Terminals Bulk Liquids Storage Facility Modification 4

State Significant Development Modification Assessment
(DA246/96-Mod-4)

June 2022

Figure 3 | Proposed modification

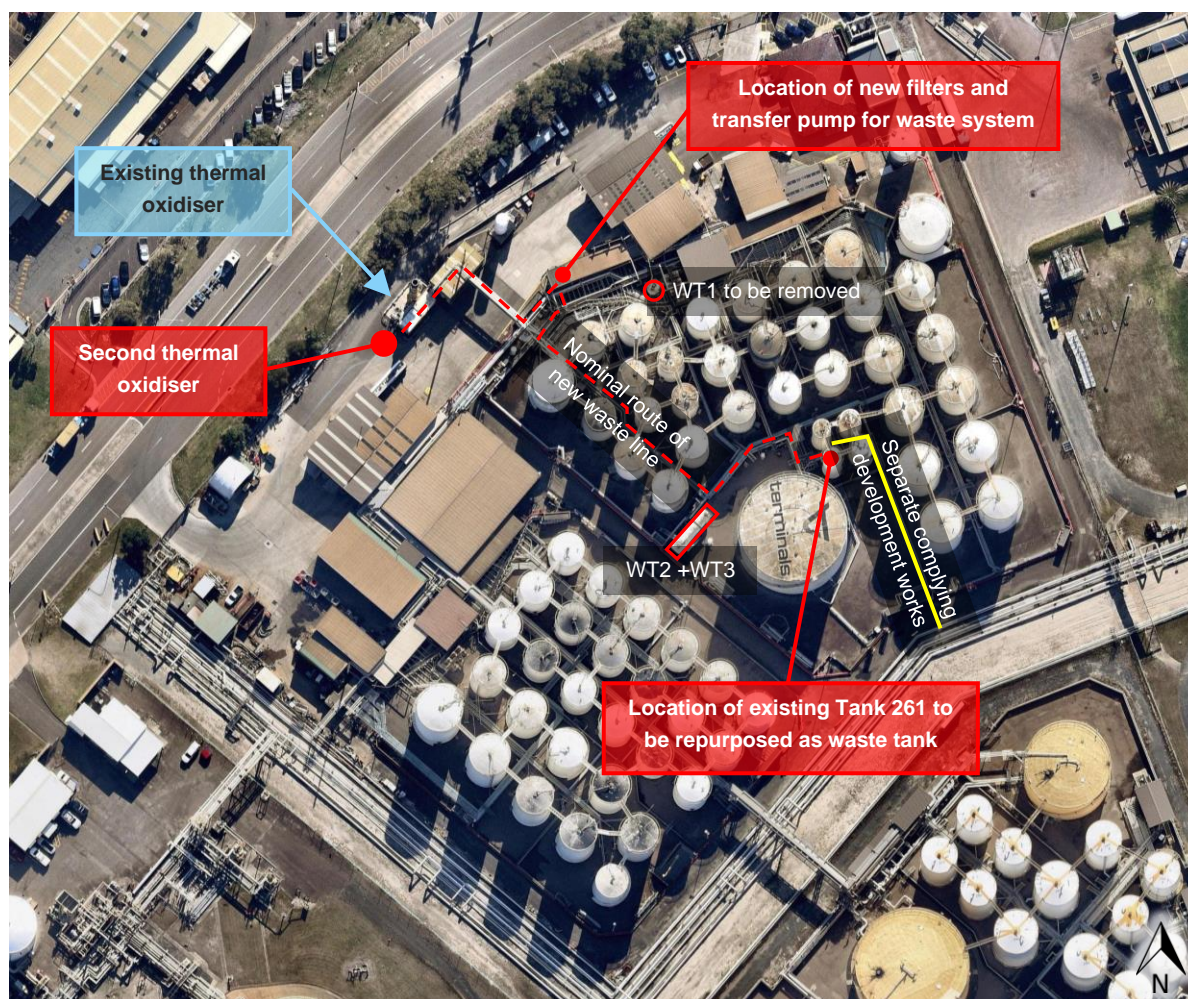
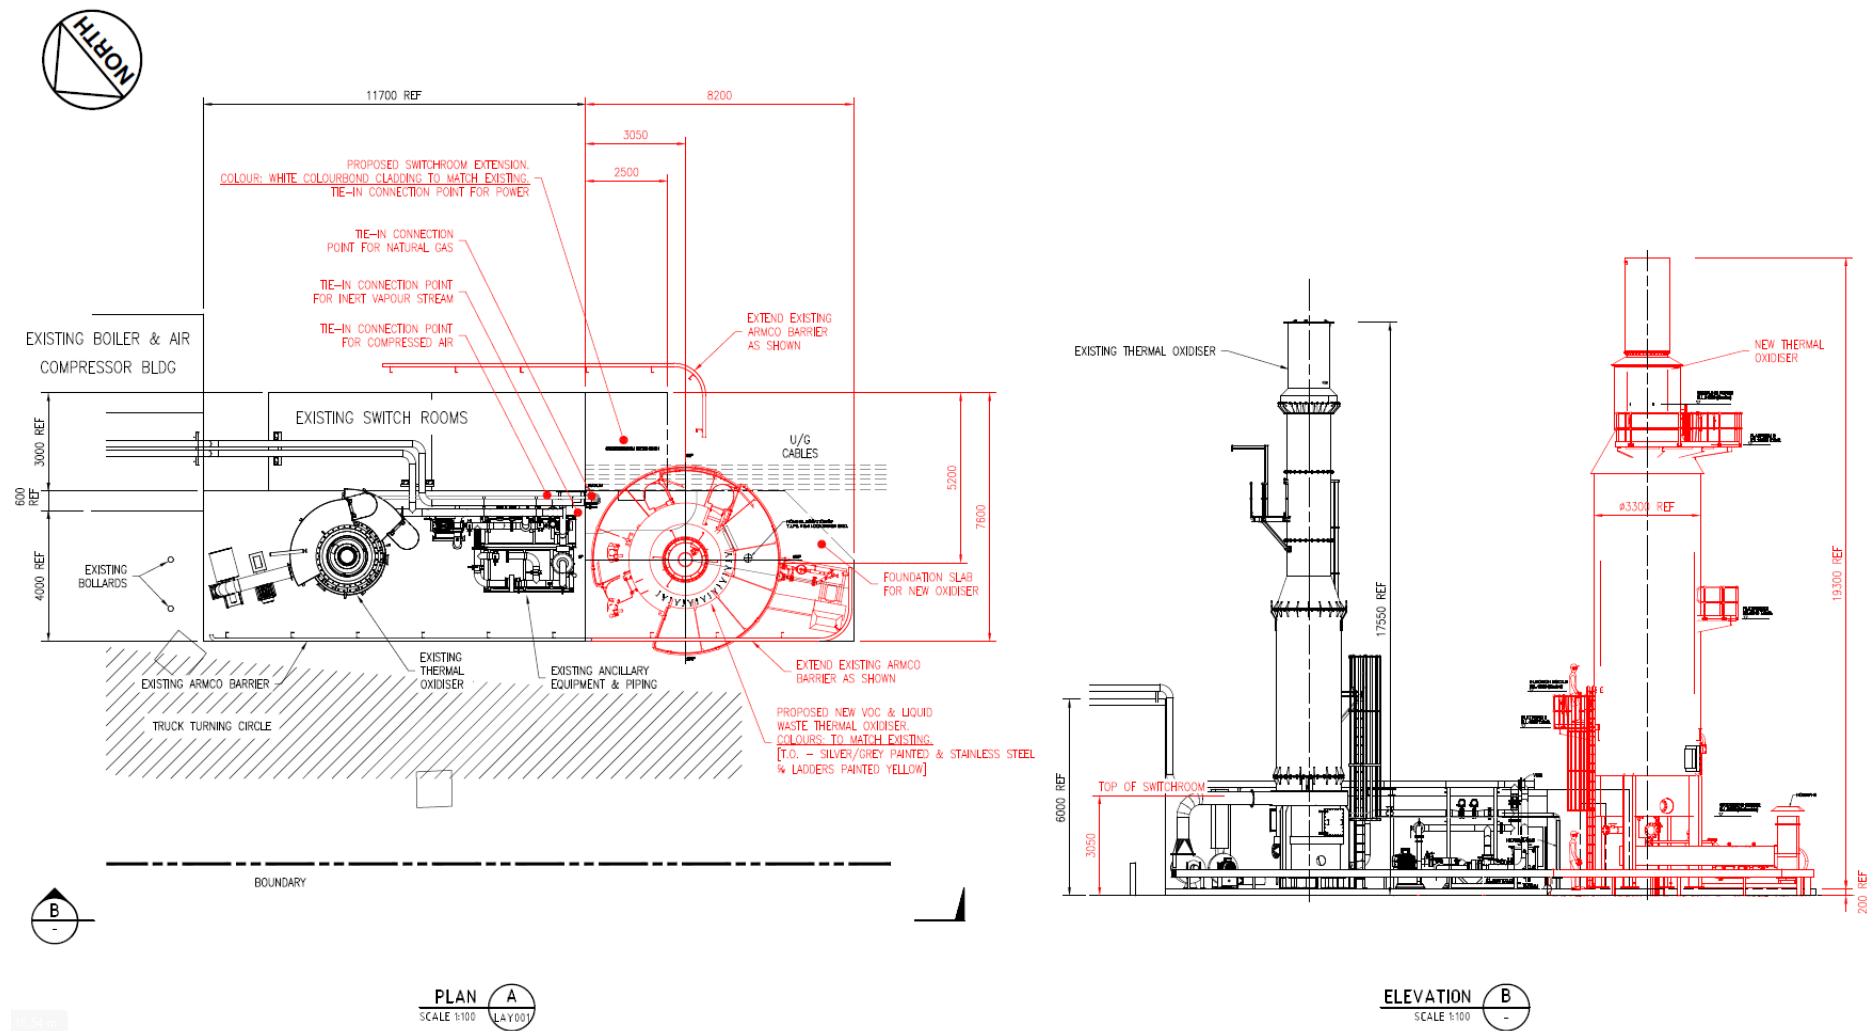
- The EPA considered this further information and advised it had no further concerns in relation to air quality impacts and recommended the following conditions:

- the vent stack of the thermal oxidiser be built to a height of at least 17.5 m above ground

- the thermal oxidiser be fitted with sampling ports to enable ongoing emission testing to be undertaken.
- The Department has considered the findings of the updated air quality assessment and the advice provided by EPA and is satisfied the proposed modification would not significantly increase ground level concentrations of air pollutants. The termination height of the proposed thermal oxidiser vent stack is 19.3 m above ground (see **Figure 4**) and would help to minimise air quality impacts to surrounding receivers.

- The Department is satisfied the existing conditions requiring the Applicant to carry out the development in accordance with the Applicant's modification assessments is sufficient in addressing the EPA's recommended height requirement. To ensure the thermal oxidiser is operated in a manner that is consistent with predicted impacts, the Department has recommended a condition requiring the Applicant to submit an air quality verification study utilising data collected by the sampling ports to verify modelled emission parameters. Should any unforeseen impacts be identified during the verification study, the Applicant would be required to implement additional mitigation measures to address the issue.
